Department of Energy

COMMENTS ON DRAFT TECHNICAL POSITION ON  
REGULATORY CONSIDERATIONS IN THE DESIGN  
AND CONSTRUCTION OF THE EXPLORATORY  
SHAFT FACILITY, JUNE 1990

Figure 1. (Proposed Revision)

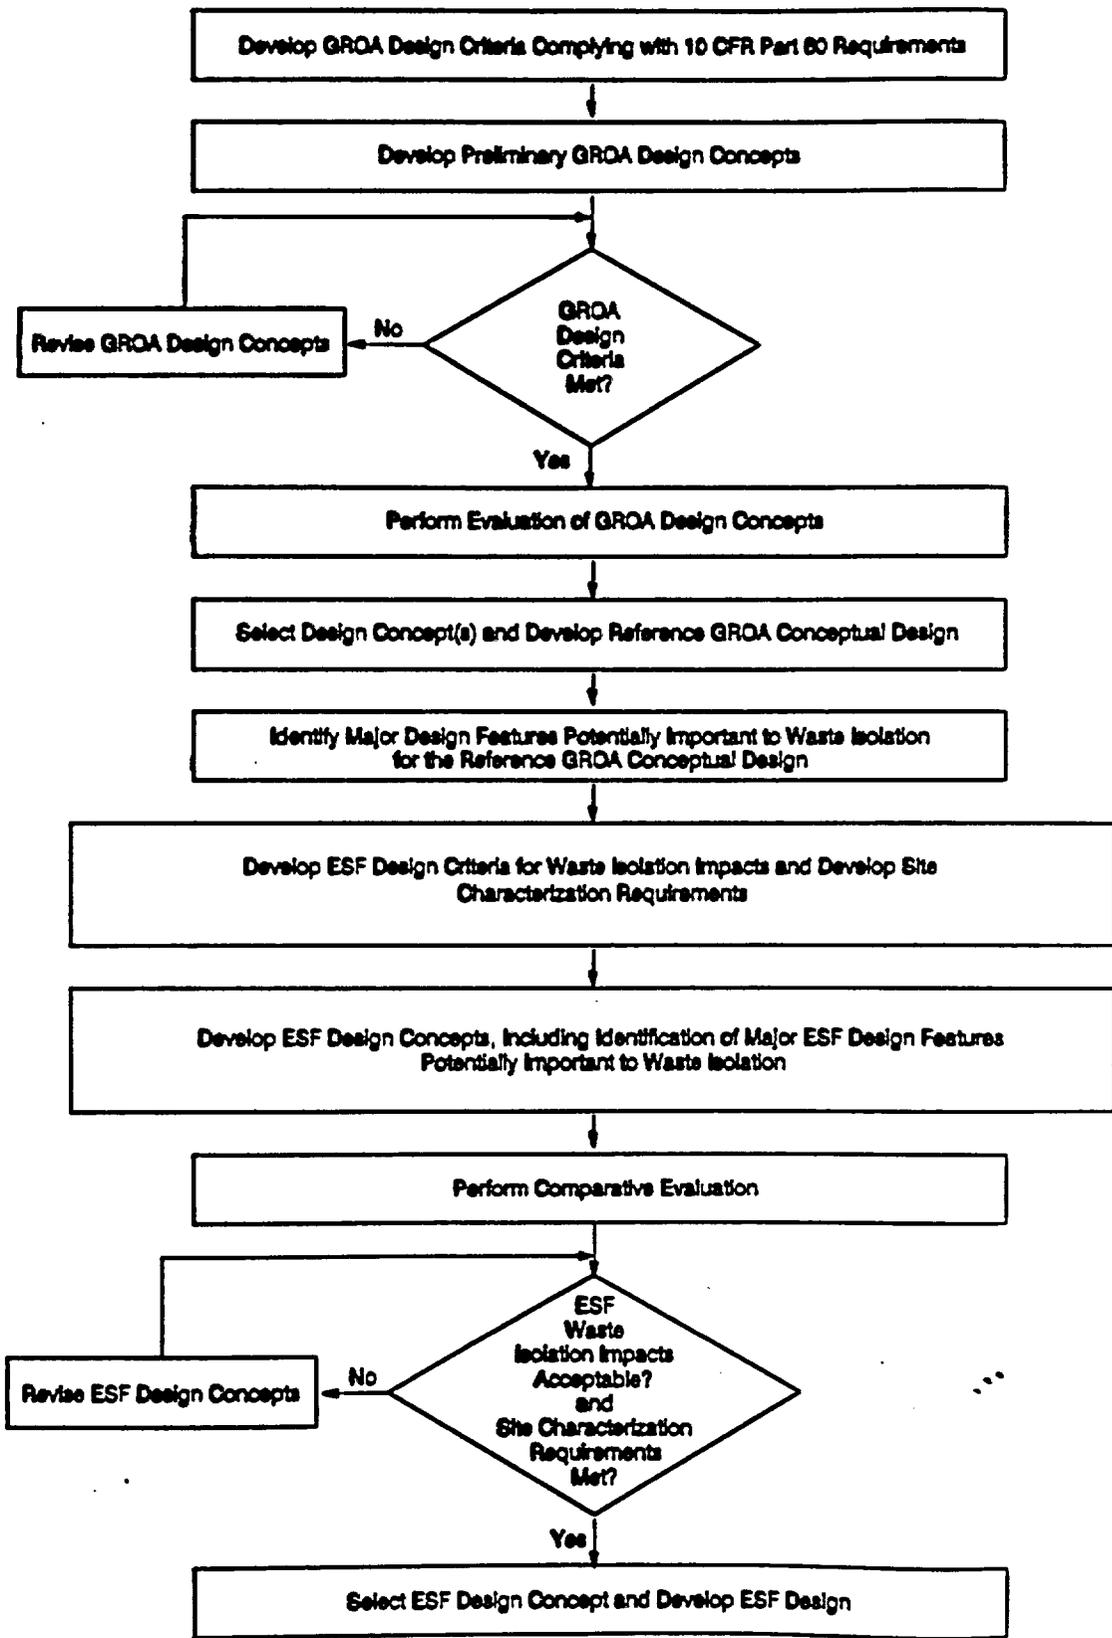
The design process presented in the text of the draft TP (and the accompanying Figure 1) calls for a comparative evaluation of GROA design features potentially important to waste isolation, in accordance with 10 CFR 60.21(c)(1)(ii)(D), prior to selection of the GROA design concept(s) and development of the conceptual design. While the DOE acknowledges that such an evaluation is needed to support the license application, we believe that this comparative evaluation at such an early stage of the design, prior to obtaining site-specific information from the site characterization program, would not provide a meaningful basis upon which decisions could be made with regard to a preferred design concept or set of concepts. Nevertheless, we do understand that such an early evaluation for major ESF design features potentially important to waste isolation should be conducted, using data currently available.

The TP states: "As required by 10 CFR 60.21(c)(1)(ii)(D), a comparative evaluation of several possible alternatives to the major design features should be performed at the initial stages of the GROA design." Figure 1 of the TP illustrates an approach the NRC staff considers acceptable for the ESF to achieve compliance with 10 CFR 60 requirements.

Figure 1 of the TP also introduces the concept of "minimizing" waste isolation impacts, which we believe is beyond the intent of the regulations. 10 CFR 60.15(c)(1) indicates that such impacts should be limited "to the extent practical", which implies that they be acceptable. The revised Figure 1 also provides recommended changes to this.

The TP indicates that GROA design features potentially important to waste isolation should be identified, and a comparative evaluation of such features be performed (consistent with 10 CFR 60.21(c)(1)(ii)(D)), prior to selection of the GROA design concept(s) and development of the conceptual design. While the DOE acknowledges that such an evaluation is needed to support the license application, we believe that this comparative evaluation at such an early stage of the design, prior to obtaining site-specific information from the site characterization program, would not provide a meaningful basis upon which decisions could be made with regard to a preferred design concept or set of concepts.

Prior to developing ESF design concepts, it is important that the appropriate ESF criteria be established for both waste isolation and site characterization needs. It is also useful to have at least a preliminary understanding of which GROA design features are potentially important to waste isolation, using the GROA conceptual design as a basis.

The DOE understands that since the permanent components of the ESF are expected to be eventually incorporated into the repository, and the ESF will be constructed prior to designing the repository, an early comparative evaluation of the major design features of the ESF that are potentially important to waste isolation needs to be conducted, using data currently available. Enclosed is a recommended revision to Figure 1 in the draft TP which incorporates the process discussed above. The actual comparative evaluation of major GROA design features important to waste isolation would be conducted after site characterization data are available, and hence is not shown on the Figure. As required by 10 CFR 60.21(c)(1)(ii)(D), that evaluation will be included in the license application.
